SCOPING OPINION:

Proposed Leoda Solar Farm

Case Reference: EN0110016

13 March 2025

Diagram not to scale

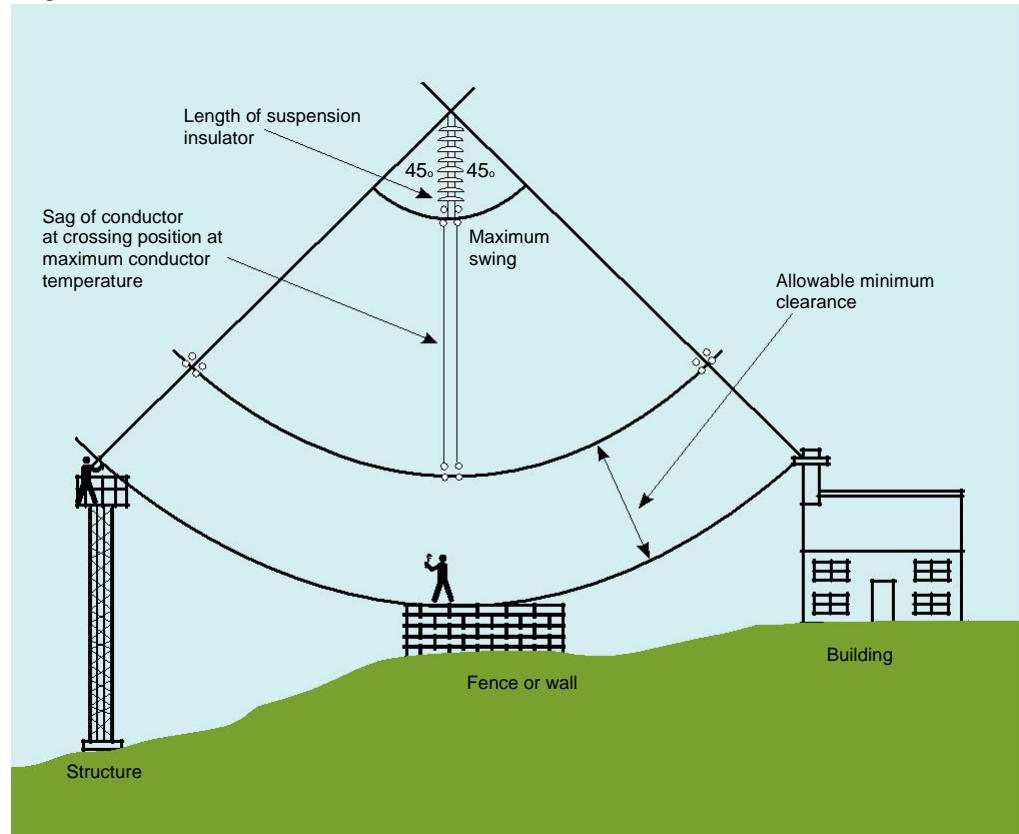
The required clearance from the point where a person can stand to the conductors is 5.3m. To be clear, this means there should be at least 5.3m from where someone could stand on any structure (i.e. mobile and construction equipment) to the conductors. Available clearances will be assessed by National Grid on an individual basis.

There should be at least 5.3m between the conductors and any structure someone could stand on

Diagram not to scale

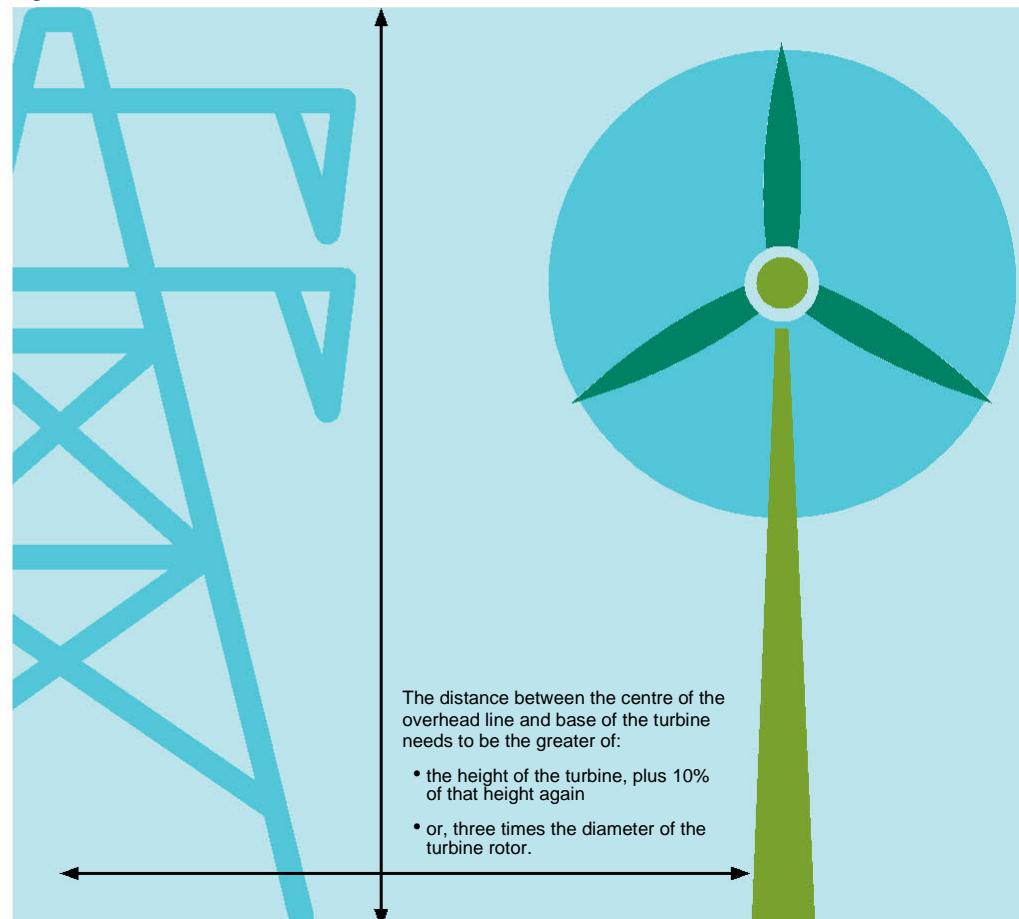
Turbines should be far enough away to avoid the possibility of toppling onto the overhead line

Diagram not to scale

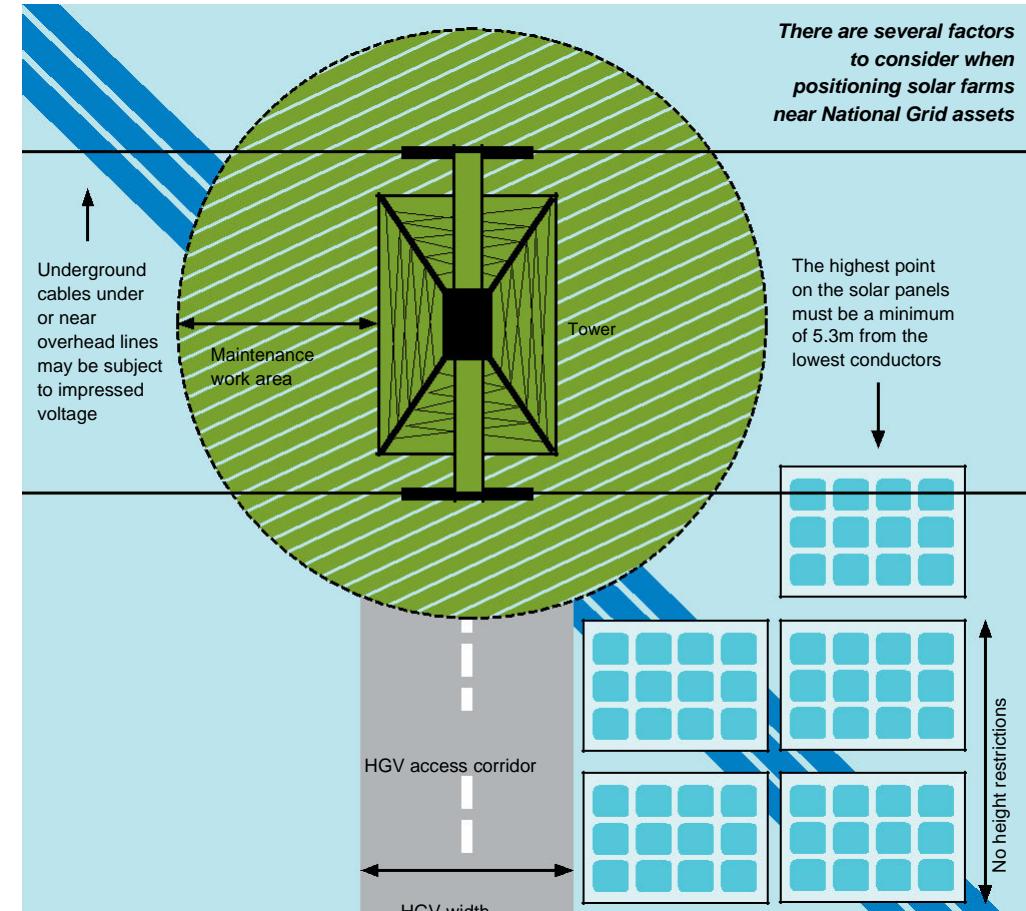
Any metallic fencing that is located under an overhead line will pick up an electrical charge. For this reason, it will need to be adequately earthed to minimise microshocks to the public.

Including access through any compound gates. During maintenance – and especially re-conductoring – National Grid would need enough space near our towers for winches and cable drums. If enough space is not available, we would require solar panels to be temporarily removed.

OHL Tower Stand Off & Reconductoring Area

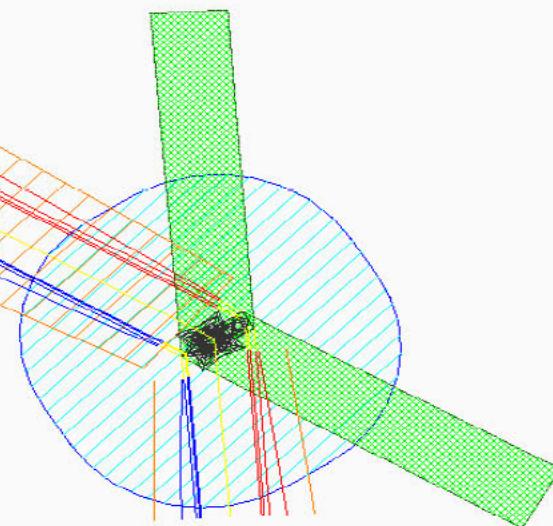
Conductor Swing zone:

Ideally no Building or Development to take place within this zone. Any proposal shall be outside the Statutory Clearances as per ENA43.8 & not interfere with maintenance requirements.

2H (2x Top X-Arm height) to allow for Conductor Pulling operations at Tension towers & Catching Off conductors at Suspension towers.
